95 BERKELEY

SELDC | OCTOBER 1, 2024

WHAT WE HEARD

ADDITION: FLOOR PLAN

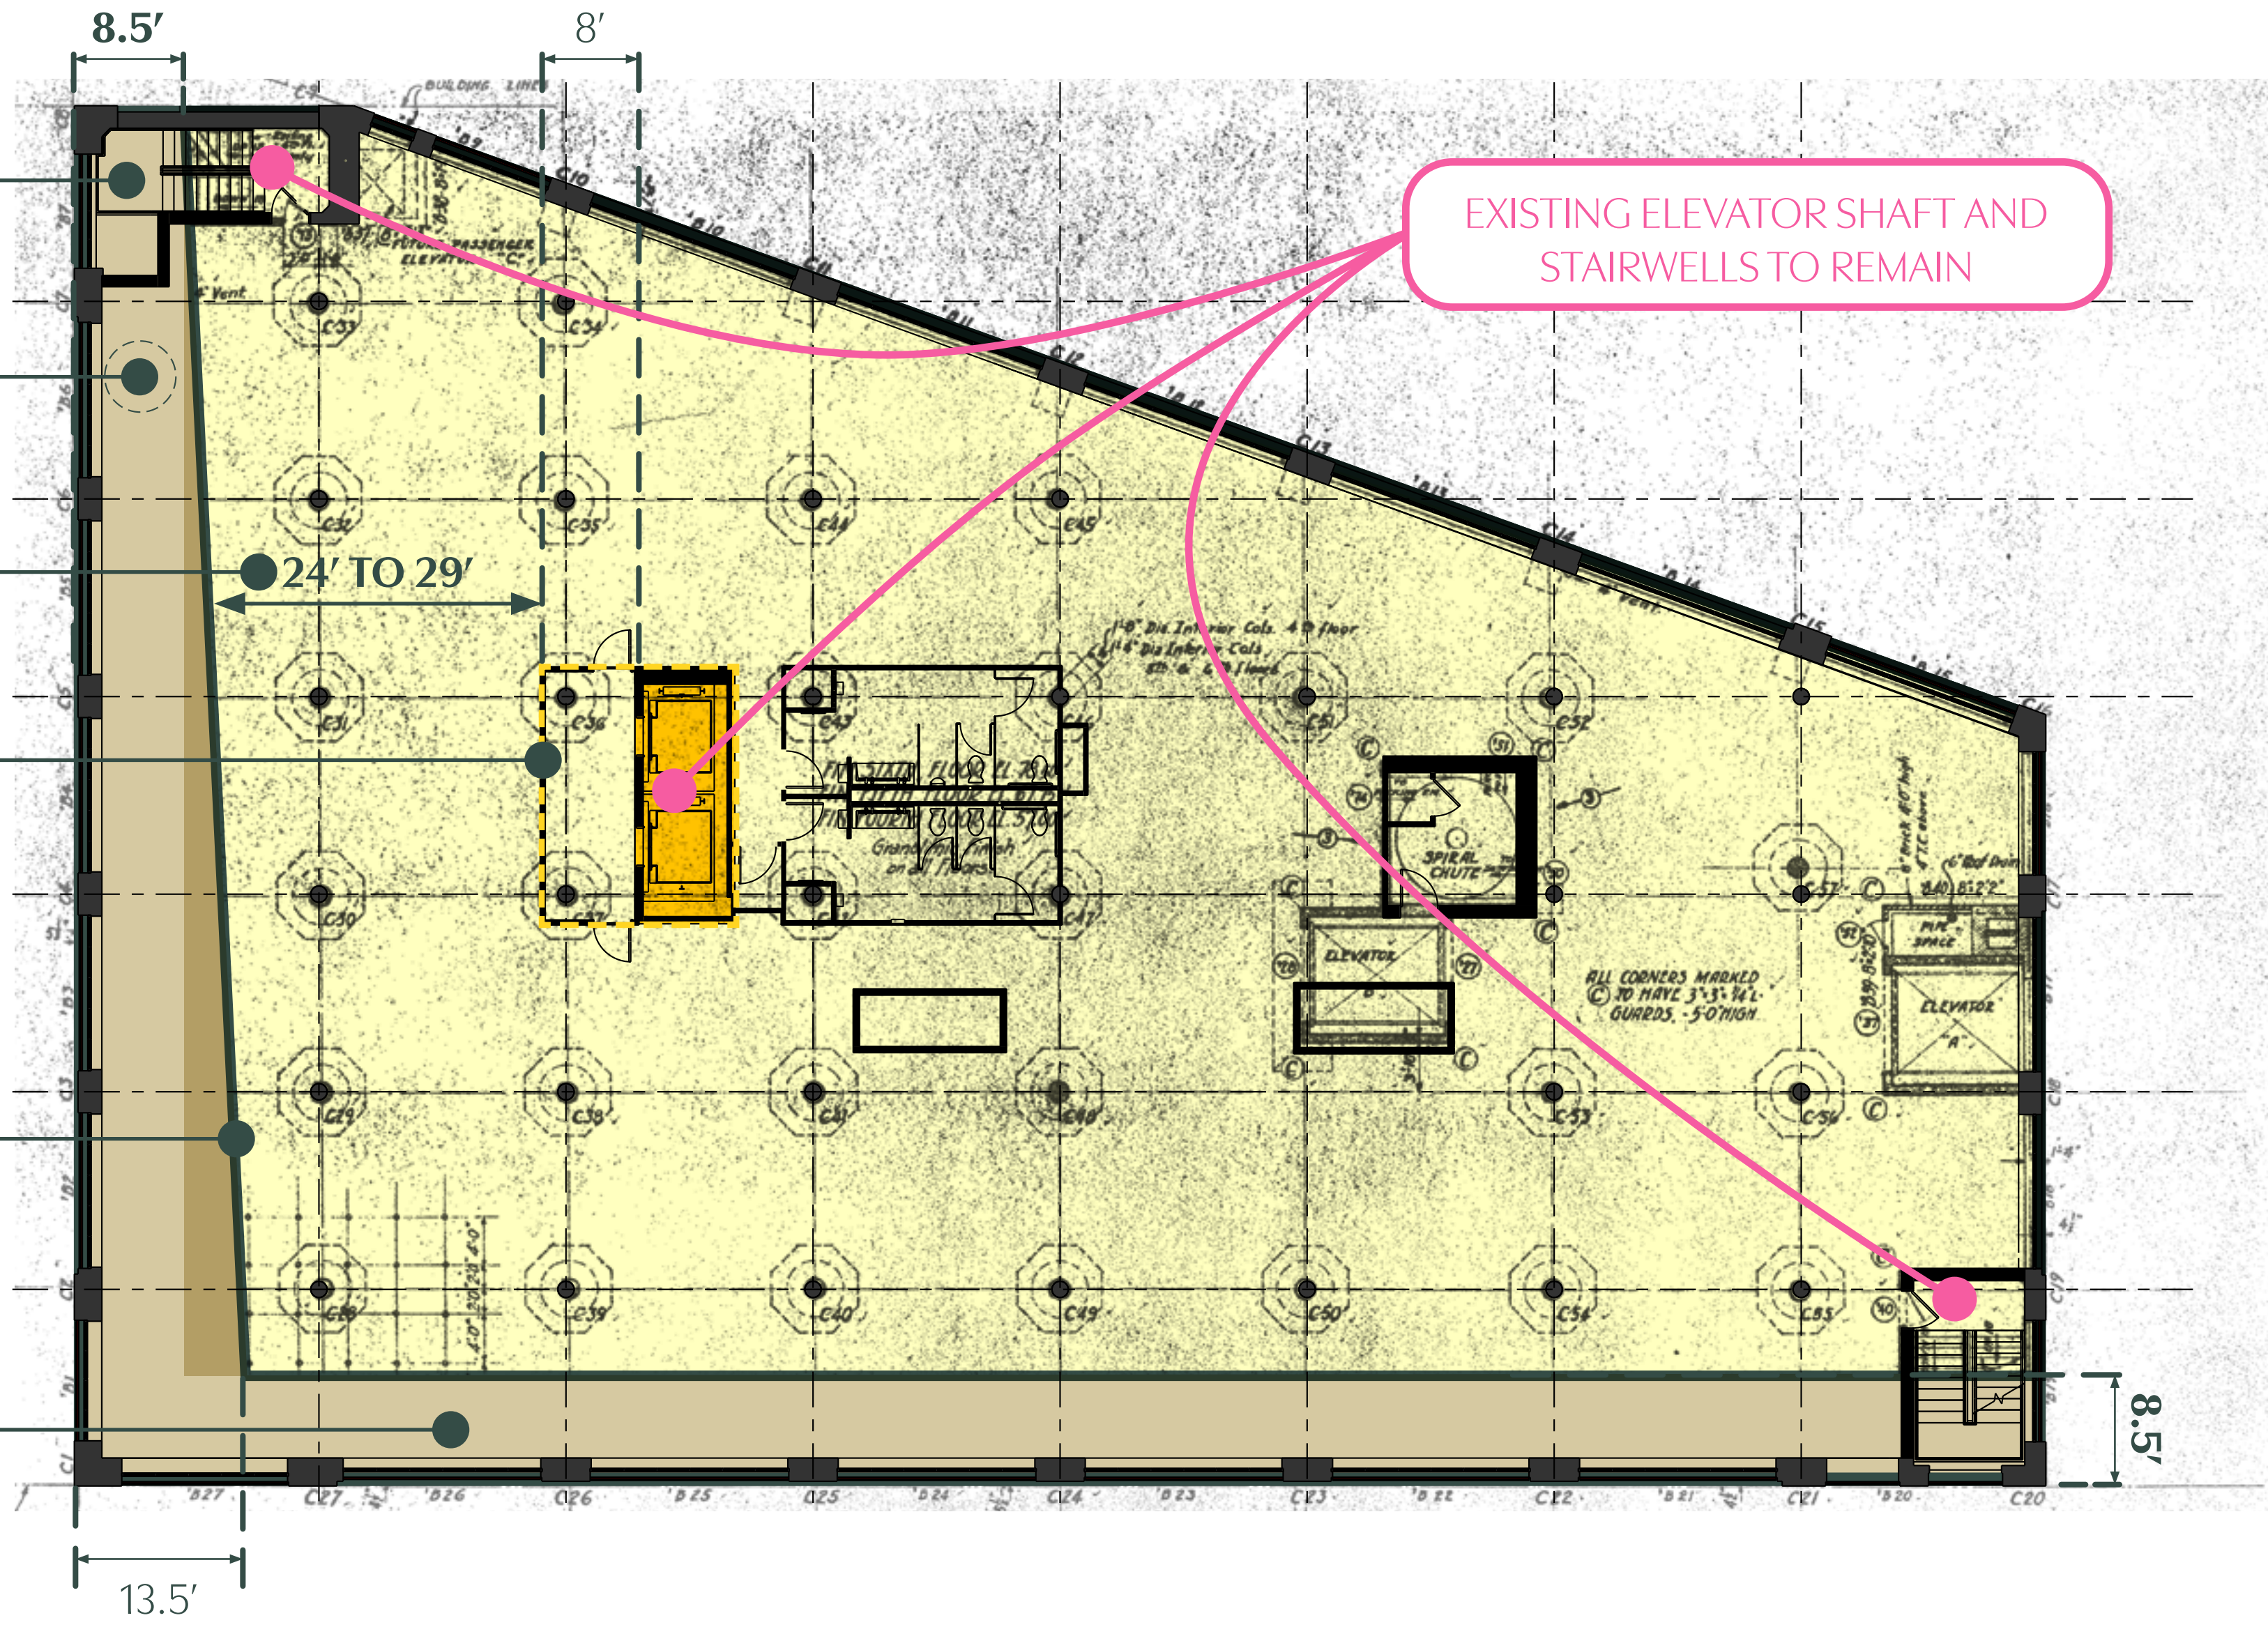
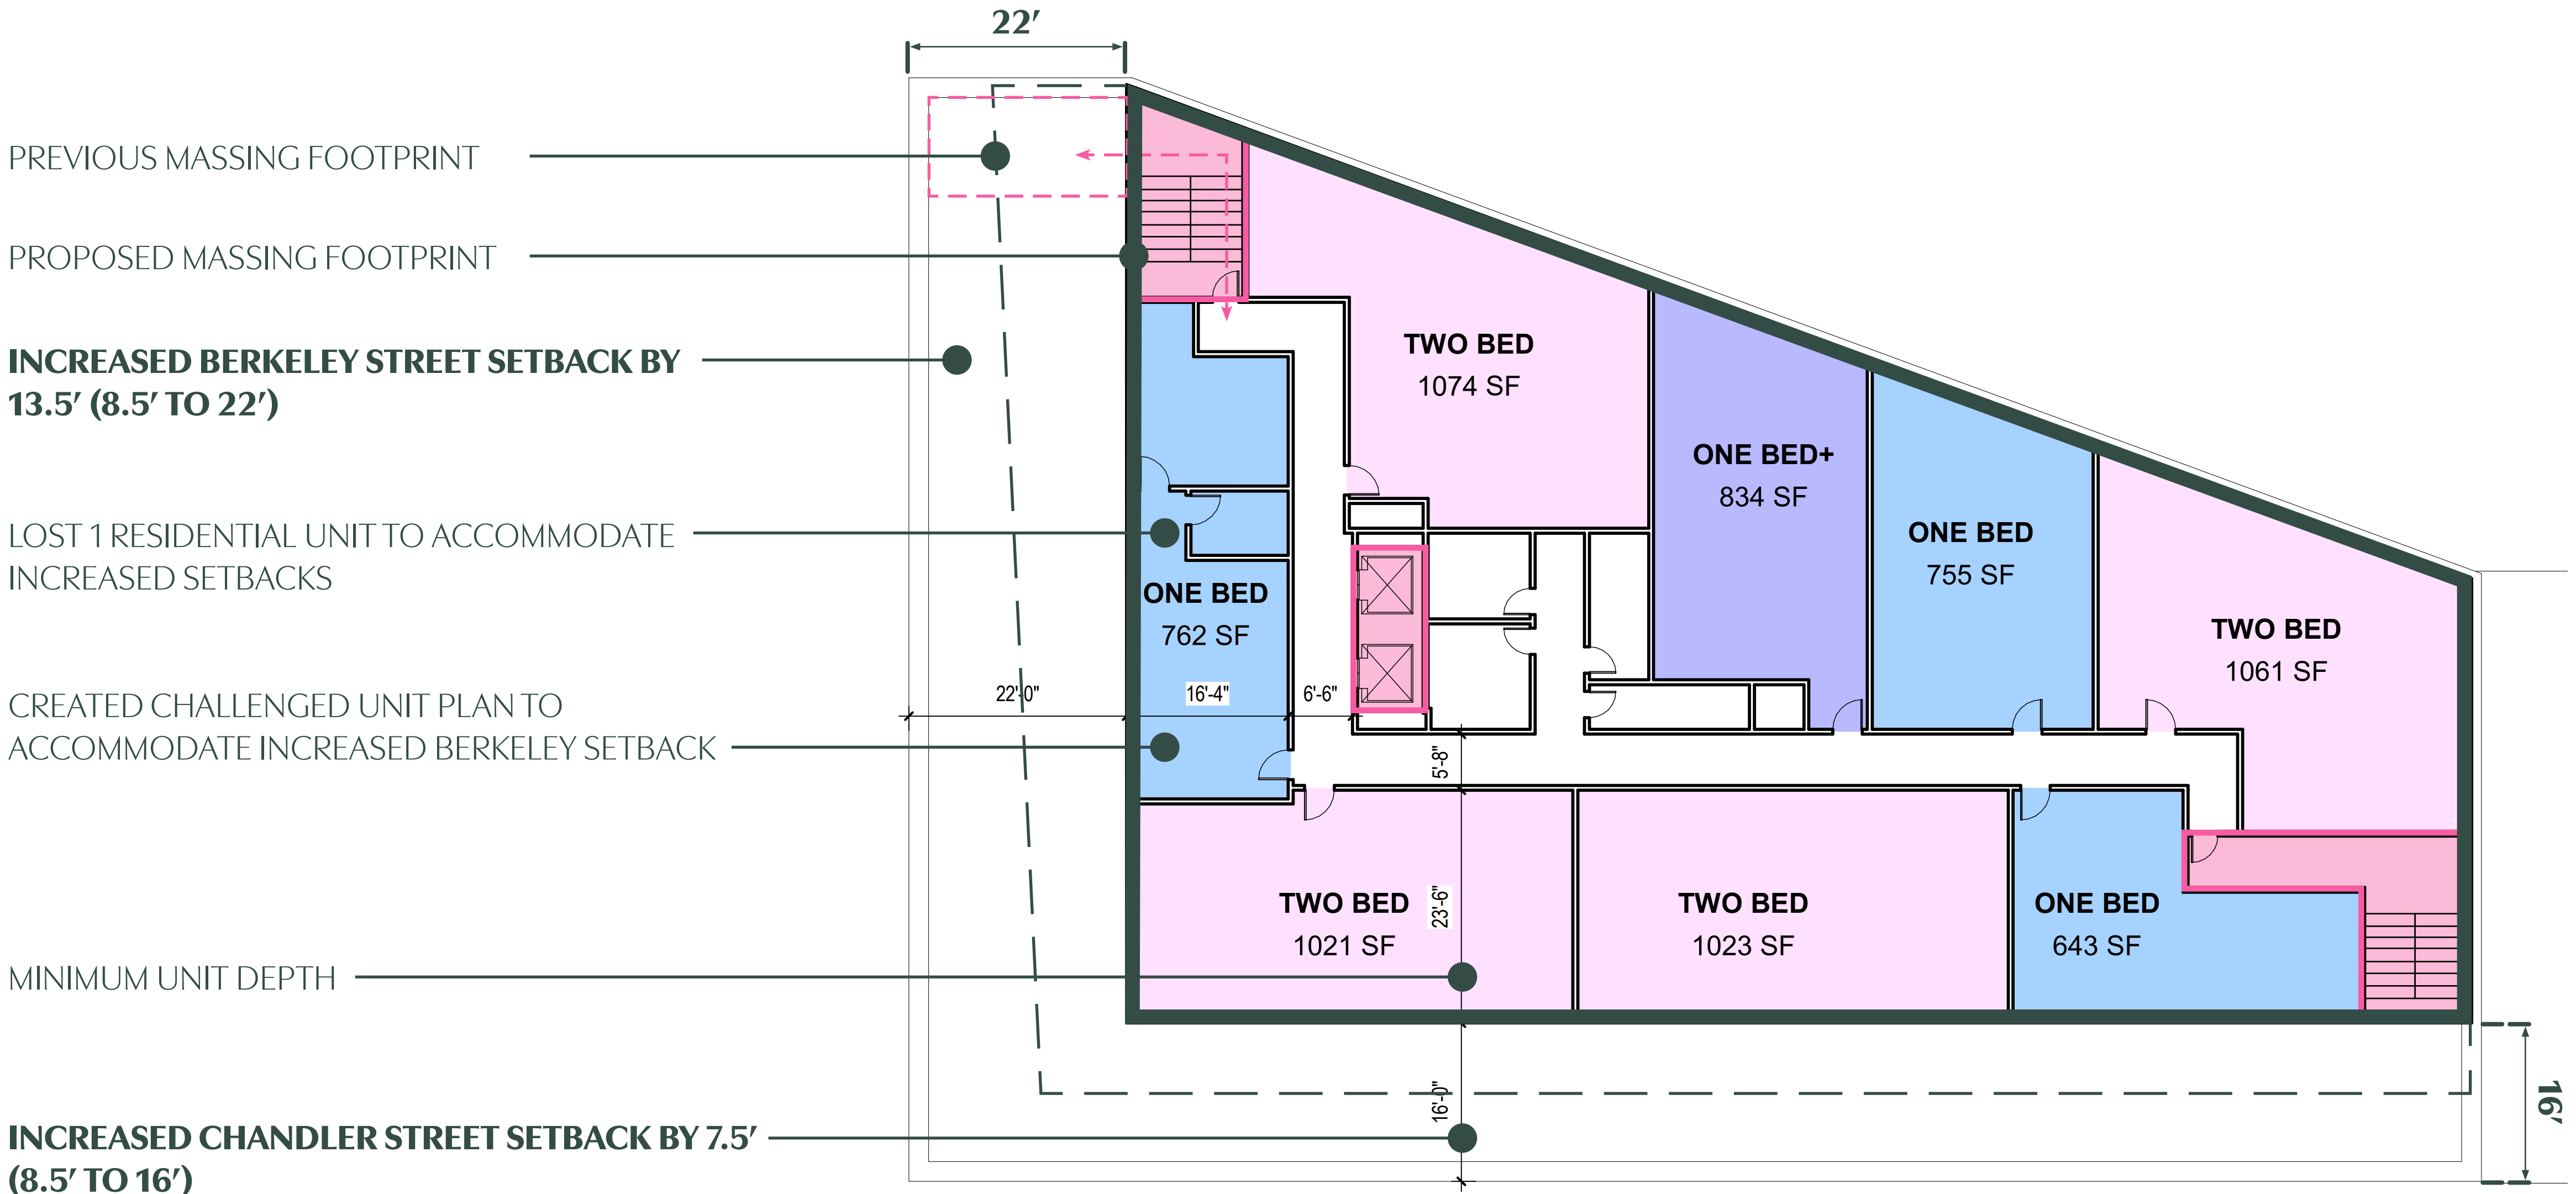
01 Financial rational for additional square footage

02 Avoid corner cornices when viewed from Berkeley

03 Reduce visual impact of addition when viewed from Chandler

TAPERED BERKELEY SETBACK FROM 8.5' TO 13.5'

MINIMUM UNIT DEPTH (TAPERS FROM 29' DOWN TO 24')

8' MINIMUM CLEARANCE IN FRONT OF EXISTING ELEVATORS TO REMAIN

TAPERED FACADE SETBACK FROM 8' TO 13.5' TO HELP ADDITION READ AS A DISTINCT, SEPARATE FORM FROM THE EXISTING BUILDING AND CREATE A MORE SIGNIFICANT SETBACK WHEN VIEWED NORTHBOUND FROM BERKELEY STREET

8.5' CHANDLER SETBACK
